BROWNS FERRY NUCLEAR PLANT (BFN) – UNITS 1, 2, AND 3 – TECHNICAL SPECIFICATIONS (TS) CHANGES TS-418 AND TS-431 – EXTENDED POWER UPRATE (EPU) – RESPONSE TO ROUND 23 REQUEST FOR ADDITIONAL INFORMATION (RAI) REGARDING STEAM DRYER SIGNAL PROCESSING (TAC NOS. MD5262, MD5263, AND MD5264)

**TENNESSEE VALLEY AUTHORITY
BROWNS FERRY NUCLEAR PLANT (BFN)
UNITS 1, 2, AND 3**

**TECHNICAL SPECIFICATIONS (TS) CHANGES TS-431 AND TS-418
EXTENDED POWER UPRATE (EPU)**

**RESPONSE TO ROUND 23 REQUEST FOR ADDITIONAL INFORMATION (RAI)
REGARDING STEAM DRYER SIGNAL PROCESSING**

Figure EMCB.202/163-2a. Cross Spectra for BFN1 main steam line A: magnitude (top) and phase (bottom) for LF conditions (black) and corresponding EIC magnitude (red).

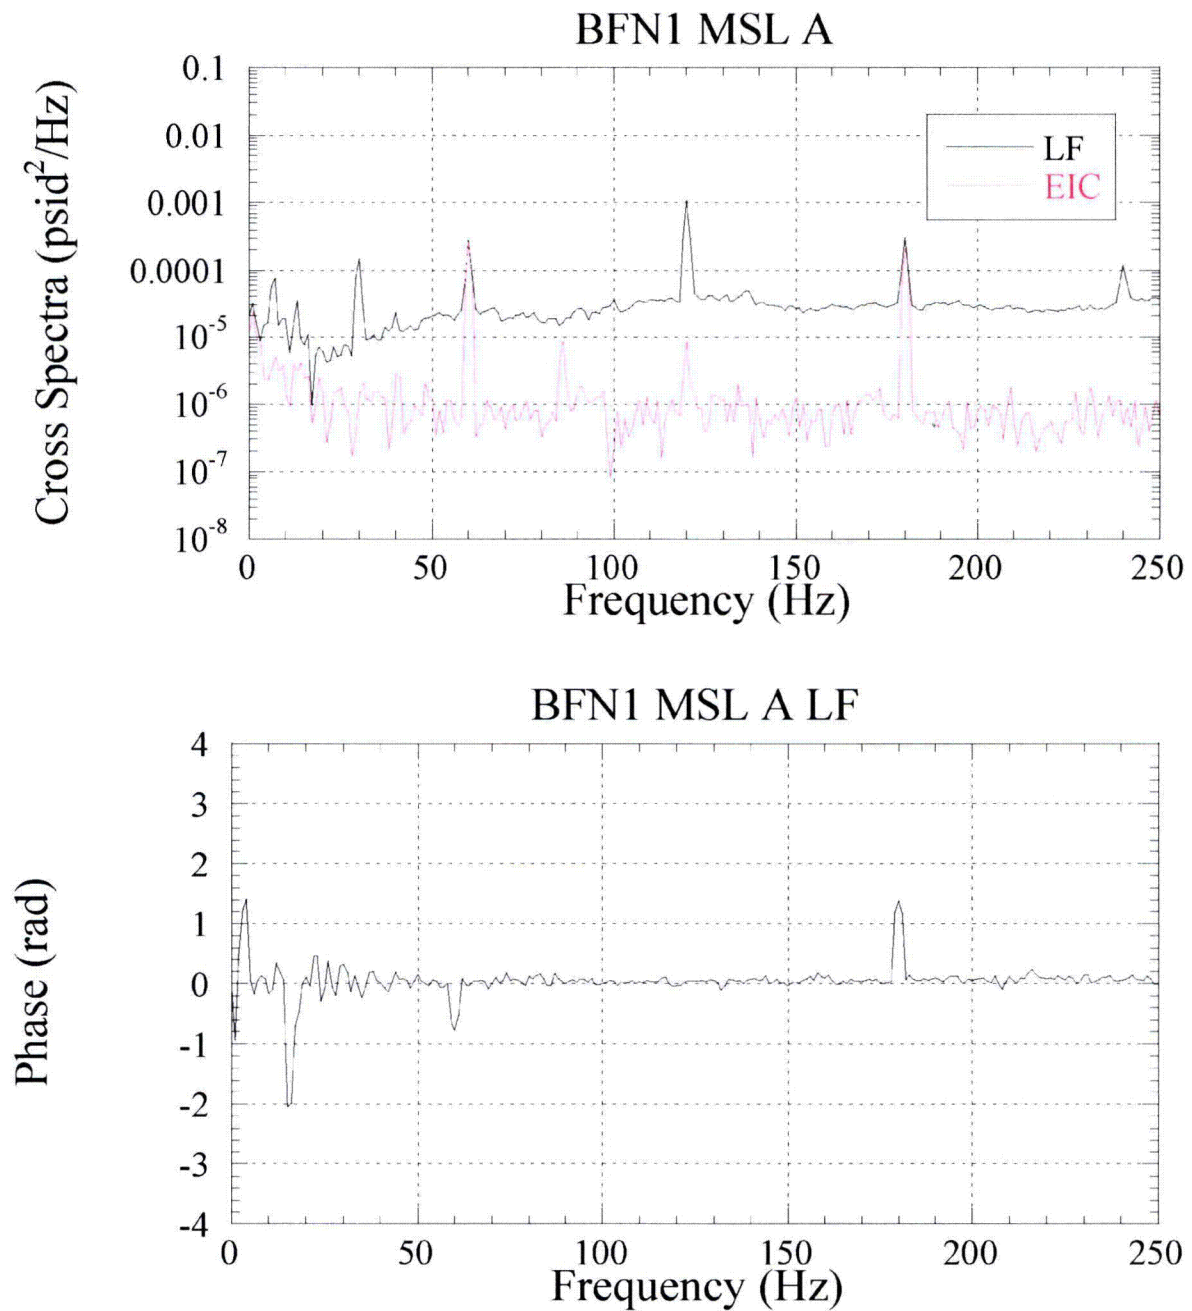
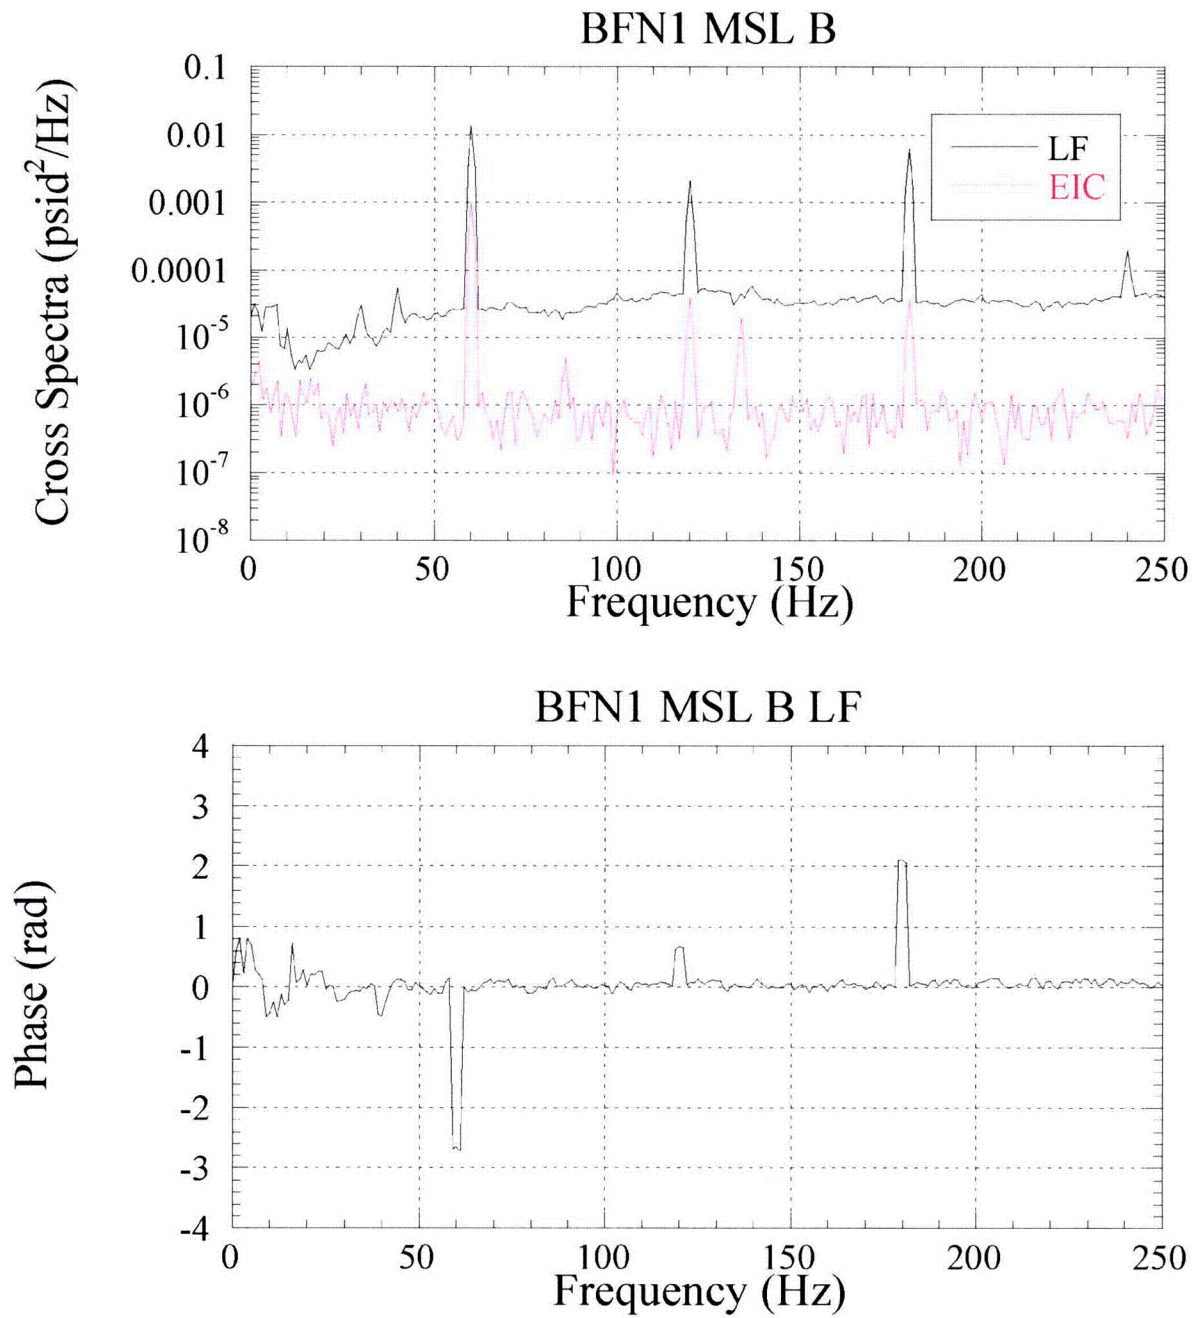
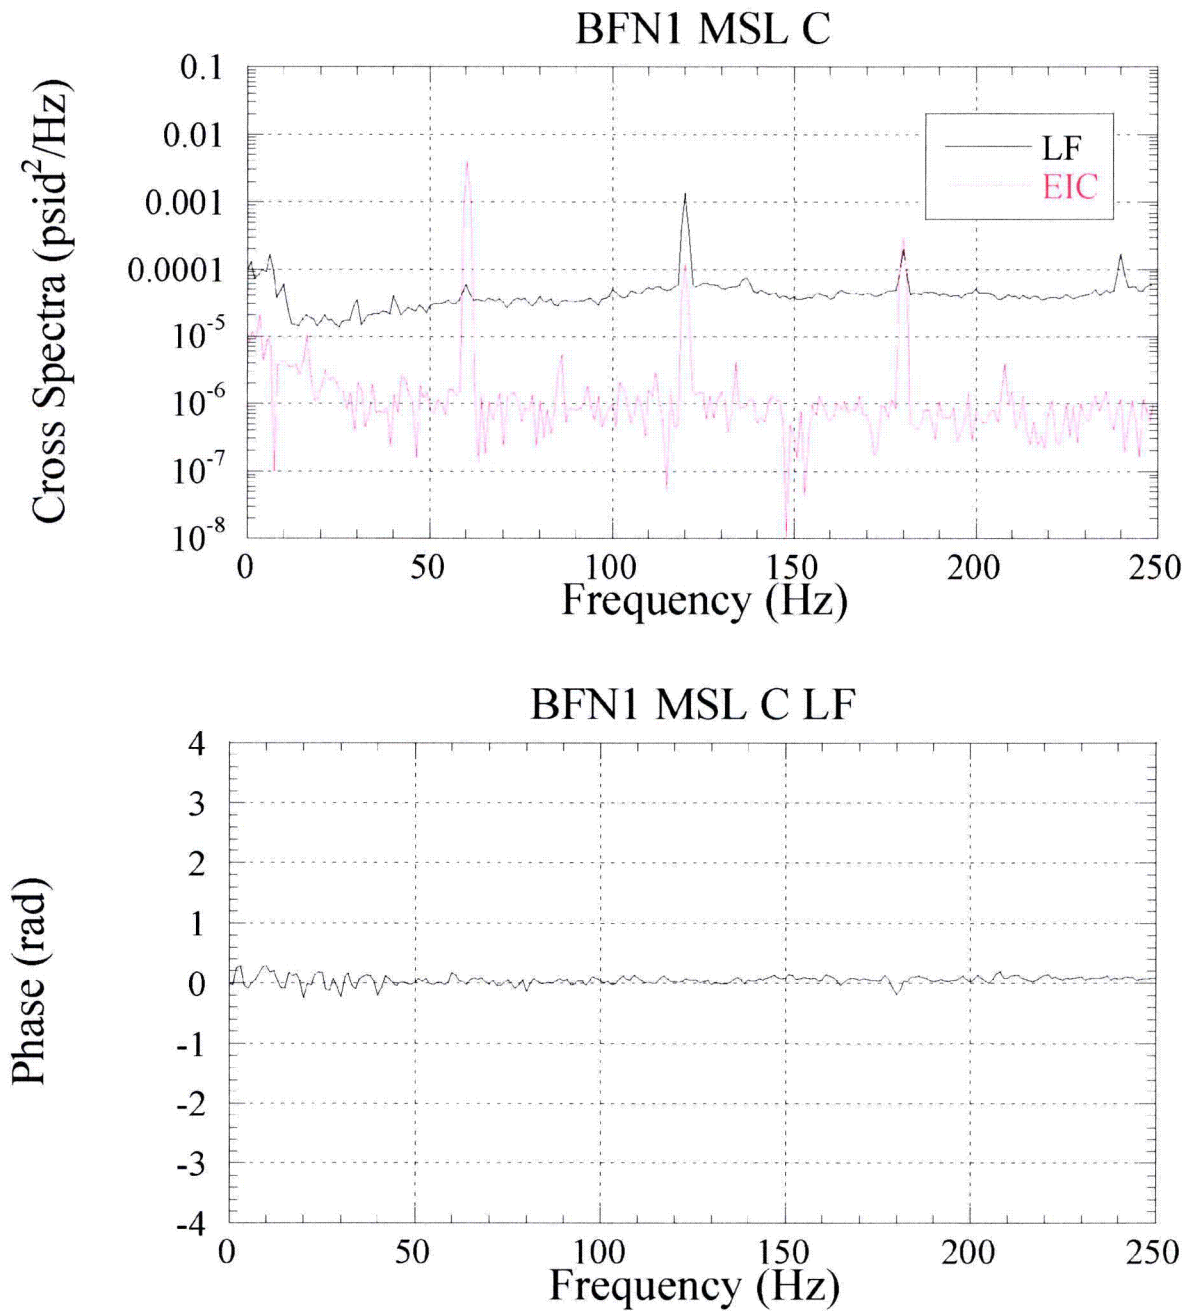
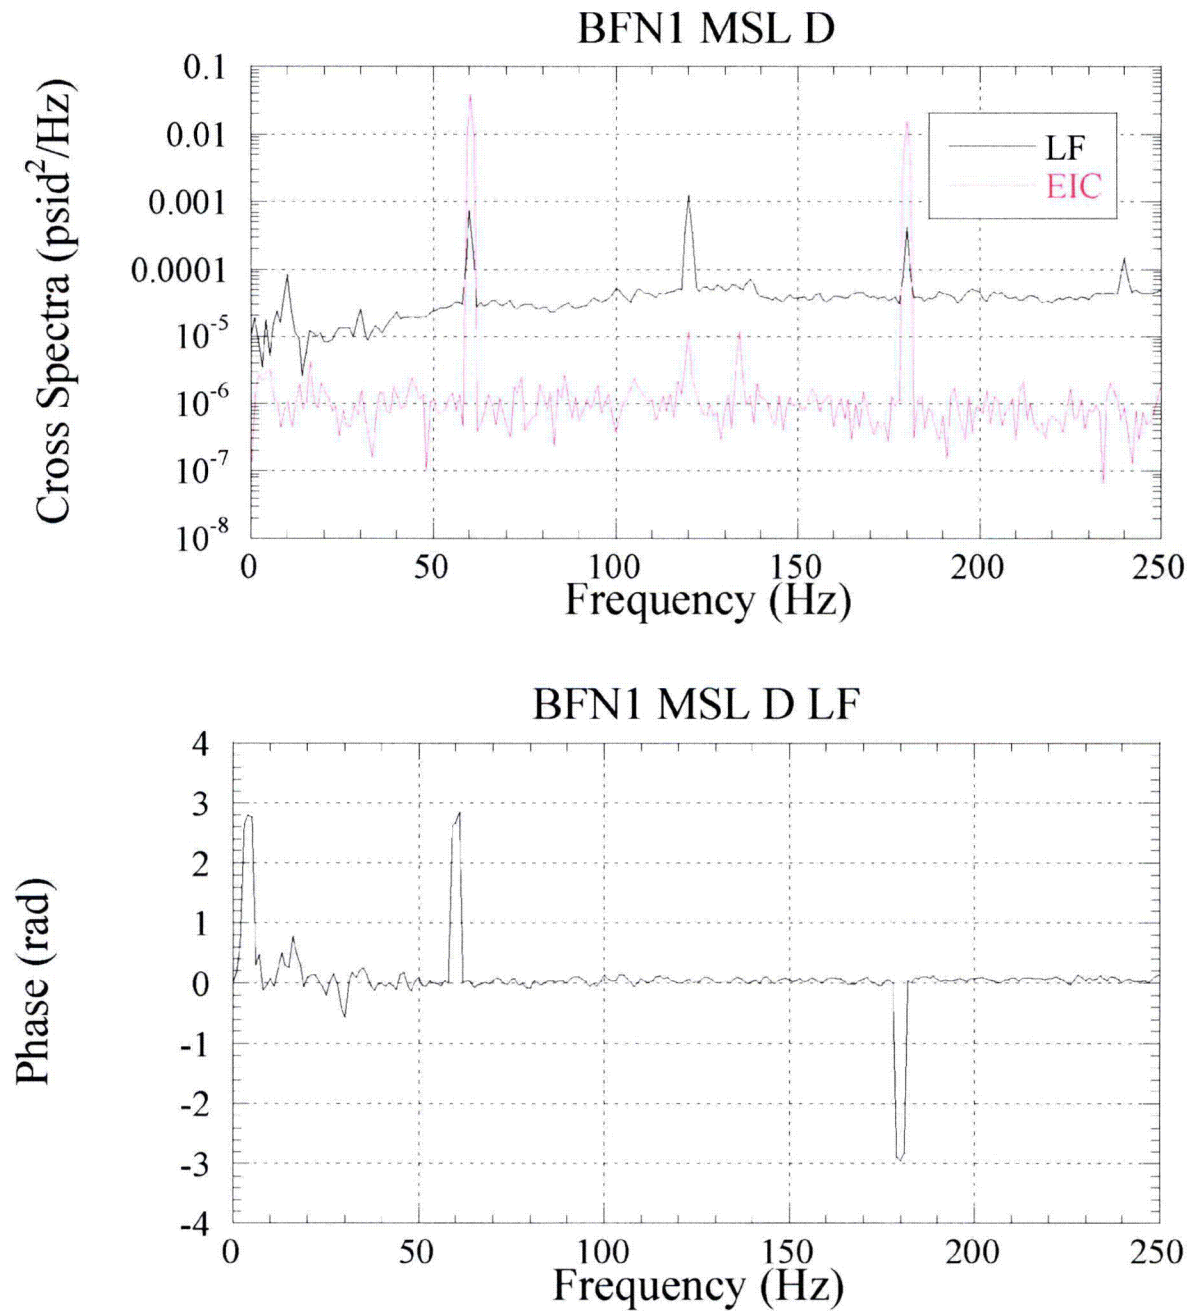
where G_{12} is the cross-spectrum between the two signals, and G_{11} and G_{22} are the autospectra of the individual signals. Explain how G_{12} is modified after using EIC signals and notch filters prior to being used in the coherence calculation. This explanation should include how both the magnitude and phase of G_{12} are modified.

Figures EMCB.202/163-2a through 2b provide the above mentioned spectra on low power, designated LF. It is clear that the cross spectrum magnitude indicates no correlation except at 60, 120, 180 and 240 Hertz (Hz).
